Minutes of the NRC/CP&L/Ebasco meeting held 8/5/75, regarding pipe rupture design criteria inside & outside containment for the Shearin Harris Nucl Plant....W/3 cys of the isometric drawing of the main steam & feedwater piping in the tunnel area, dated 7-25-75....

Enclosed are the minutes of the NRC/CP&L/Ebasco meeting held on August 5, 1975, regarding pipe rupture design criteria inside and outside containment for the Shearon Harris Nuclear Power Plant (SHNPP). We have also enclosed three copies of the isometric drawing of the main steam and feedwater piping in the tunnel area, Drawing No. SK-M-321 dated July 25, 1975, in which we have incorporated the information as discussed and referenced in the meeting minutes.

SHEARON HARRIS NUCLEAR POWER PLANT  
MEETING MINUTES NRC/CP&L/EBASCO  
BETHESDA, MD.  
AUGUST 5, 1975

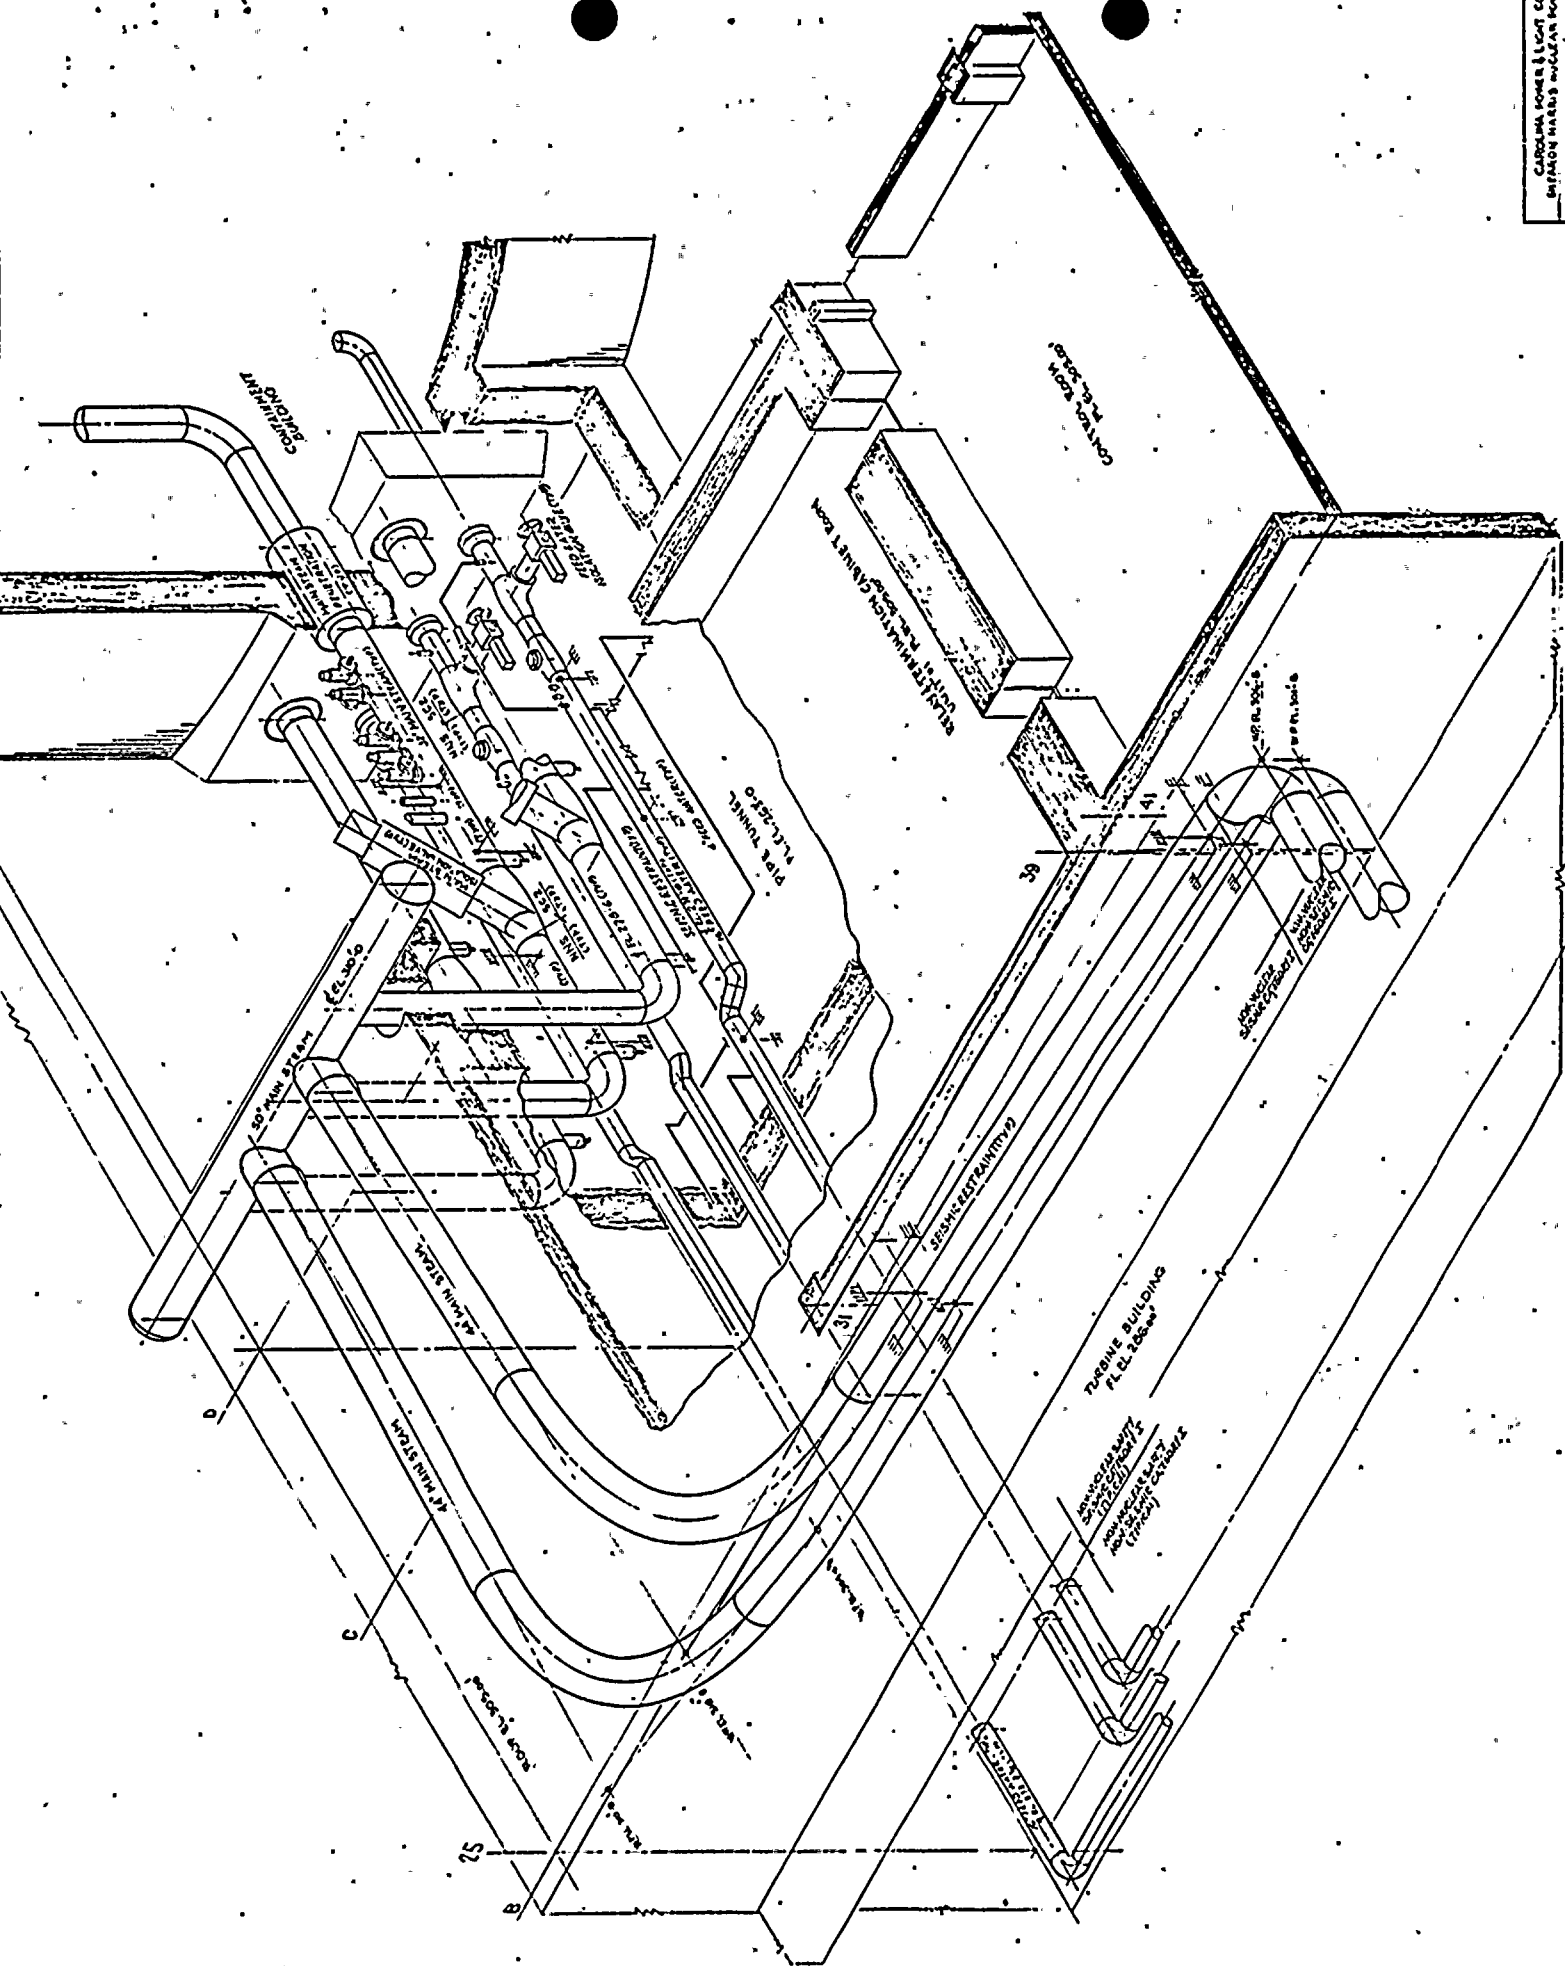
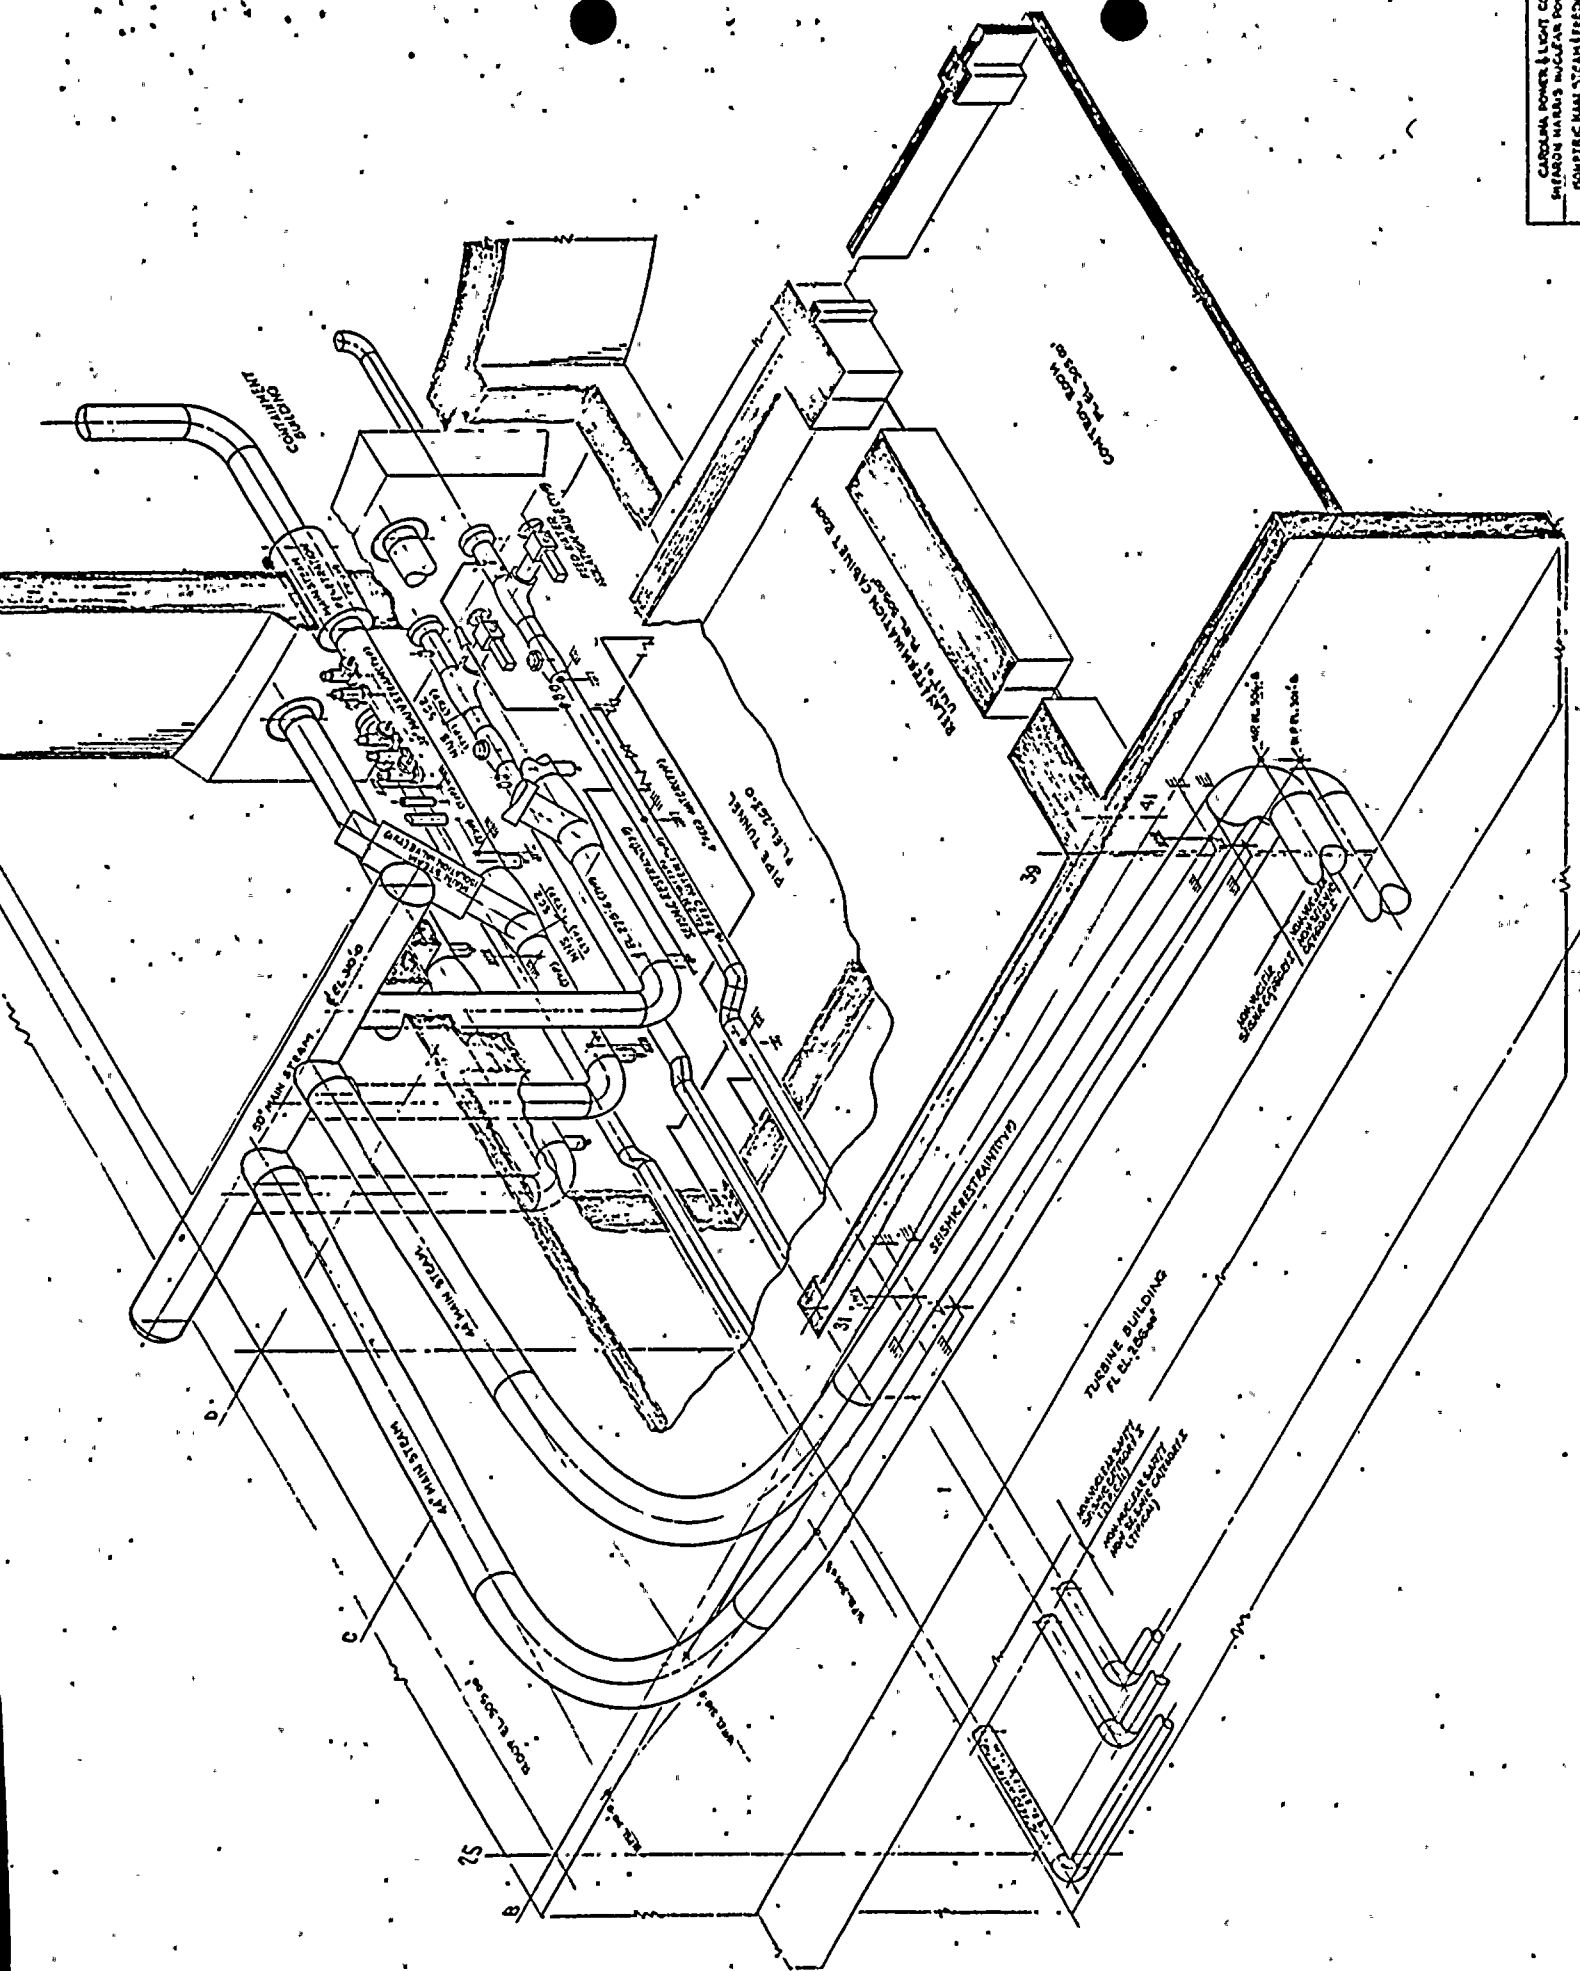
- d. SHNPP Units 1-4 Break Exclusion Region for Main Steam Piping between Isolation Valve and Pipe Rupture Restraint System: Carolina Power & Light indicated that, on the basis of the following design considerations, the pipe rupture restraint system has been located at the discharge of the main steam header at El.310 adjacent to the Auxiliary Building roof (see attached Sketch SK-M-321, 7/25/75).

NRC agreed that the following criteria could be applied for piping from the isolation valve to the end of the pipe rupture restraint system, which extends just downstream of the main steam header:

The piping downstream of the pipe rupture restraint system is presently classified as non-Nuclear Safety/Seismic Category I and designed to appropriate code stress limits and 10CFR50 Appendix B QA requirements. The location of the first main steam line break in this section of piping is postulated at the elbow in the Turbine Generator Building (adjacent to the Auxiliary Building) where the steam lines are declassified to non-Seismic Category I. Should CP&L elect to classify the main steam piping downstream of the pipe rupture restraint system as Non-Seismic Category I, then the requirements of BTP APCSB 3-1, Section B.3.d must be met. The attached figure illustrates the present classification of the various portions of main steam piping and the extent of the region not subject to postulation of pipe break.

- 1. Piping may be classified as non-Nuclear Safety/Seismic Category I.
  - 2. Code stress limits may be applied provided the requirements of 2(b) above, are met.
- e. Branch Lines:
  - 1. The design criteria for MEB 3-1, Section B.1.b apply to branch lines (e.g., auxiliary feedwater and main steam line to auxiliary turbine) up to the end of the pipe rupture restraint system as in the case of main runs.
